Access Compliance Report Public Rights-of-Way (Curb Ramps)

Main Street: FRONTERA_ST		Cross Street: N_GLASSELL_ST		Location:	NE
ADA ID: RPAT220127092606	Ramp Type:Type 1 - Perpendicular	Initial Pass/Fail: Fail	Overall Compliance: No	Severity Score:	20

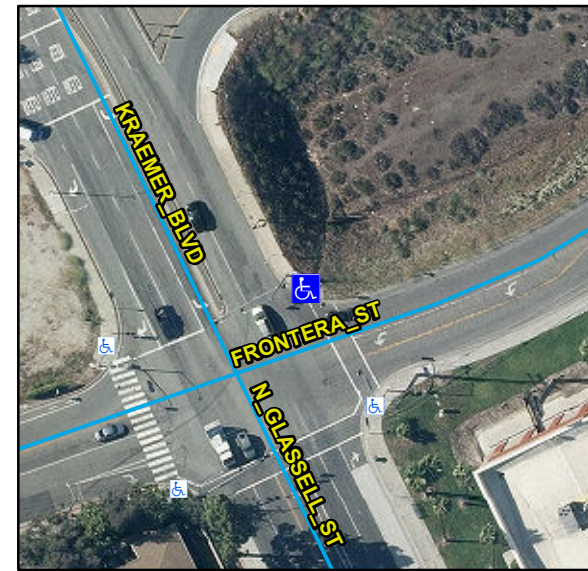
R304.2.2, R204.3, R304.5.1, R304.5.3, R302.7, STD 1115

Compliance	Description	Data	Compliance	Description	Data
N/A	Ramp Length (in)	111	N/A	Flare Type LT	
No	Ramp Width (in)	45			N/A
Yes	Ramp Run Slope (%)	5.1	N/A	Flare Slope LT (%)	N/A
No	Ramp Cross Slope (%)	2.5	N/A	Flare Traversable LT	N/A
N/A	Landing Present	N/A	N/A	Flare Type RT	
N/A	Landing Length (in)	N/A			N/A
N/A	Landing Width (in)	N/A	N/A	Flare Slope RT (%)	N/A
N/A	Landing Run Slope (%)	N/A	N/A	Flare Traversable RT	N/A
N/A	Landing Cross Slope (%)	N/A	N/A	DWS Provided	N/A
N/A	Landing Movement Obstructed?	N/A	N/A	DWS Contrast	N/A
	Landing Movement Type	N/A	N/A	DWS Length (in)	N/A
N/A	Landing Shared	N/A	N/A	DWS Full Width	N/A
N/A	Clear Space	N/A	N/A	DWS Offset Left (in)	N/A
N/A	Clear Space To Crosswalk (in)	N/A	N/A	DWS Offset Right (in)	N/A
N/A	Marked Crosswalk 1	Yes	N/A	Marked Crosswalk 2	N/A
	Crossing 1 Direction	S		Crossing 2 Direction	N/A
	Marked Crosswalk 1 Width (in)	128		Marked Crosswalk 2 Width (in)	N/A

N/A	Ramp Inside Crosswalk 1	No	Yes	Ramp Inside Crosswalk 2	N/A
	Crossing 1 Slope (%)	4		Crossing 2 Slope (%)	N/A
	Crossing 1 Cross Slope (%)	0.1		Crossing 2 Cross Slope (%)	N/A
N/A	Gutter Ponding	N/A	No	Curb Slope	9.9
Yes	Gutter Lip Height (in)	0		Road Run Slope (%)	N/A
N/A	Gutter Run Slope (%)	N/A		Road Cross Slope (%)	N/A
N/A	Gutter Cross Slope (%)	N/A			
No	Overall Surface Condition:	Poor	No	Perp Joint Present	No
	Cross Gutter Present?	No		Spandrel Present?	No
	Replace Cross Gutter?	N/A		Replace Spandrel?	N/A

Remove & Replace Entire Ramp. Restripe Crosswalk.
